Applicant/Serial No.: Haruhiro Watanabe / 10/624,168
Filed/Conf. No. 07/21/2003 / Conf. No. 6365
Examiner/Group: Michael S. Lowe / 3652
Amendment mailed: 12 / 08 / 2005
Attorney File: MM0721US (#90326)

R E M A R K S

ANNOTATED SHEET SHOWING CHANGES.

FIG. 10(d)

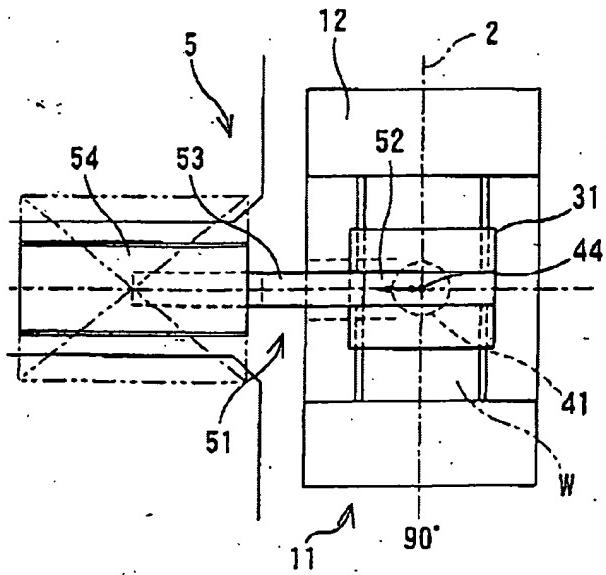
Examination of the present application is acknowledged. According to the Office Action dated September 8, 2005, the drawings were objected to because they failed to depict the "transfer of an article from between the article supporting body and the article handling section" as recited in claim 1. Claim 3 was rejected under 35 U.S.C. 112, second paragraph, because of the statement "at least partially in a synchronized manner." Finally, claims 1-6 were rejected under 35 U.S.C. 103(a) as being obvious over Brudi (U.S. 3,757,977) in view of Derby (U.S. 6,394,736). By the present amendment, each of these matters has been addressed.

Turning first to the drawings, new Figs. 10(d) and 12(b) have been added, and the Annotated Sheets showing Changes with new figures are attached. Replacement Sheets in draft form are also attached, but they will be replaced once approved by the Examiner.

These figures show the transfer of an article W supported by upper fork member 54 to the article unloading section 5 following the step shown in Fig. 10(c) pursuant to the first embodiment of the invention. Likewise, in accordance with the second embodiment of the invention, Fig. 12(d) follows the action subsequent to that of Fig. 12(c), and upper fork member 54 has been moved to article loading section 5. The specification has been amended accordingly, since paragraphs [0056] and [0064] have been amended to reflect that the details set forth in those paragraphs are shown in the drawings. It is requested that the objection to the drawings be withdrawn. It is furthermore requested that the Examiner advise the undersigned if the drawings are in an acceptable form, after which formal drawings will be filed for the above-identified application.
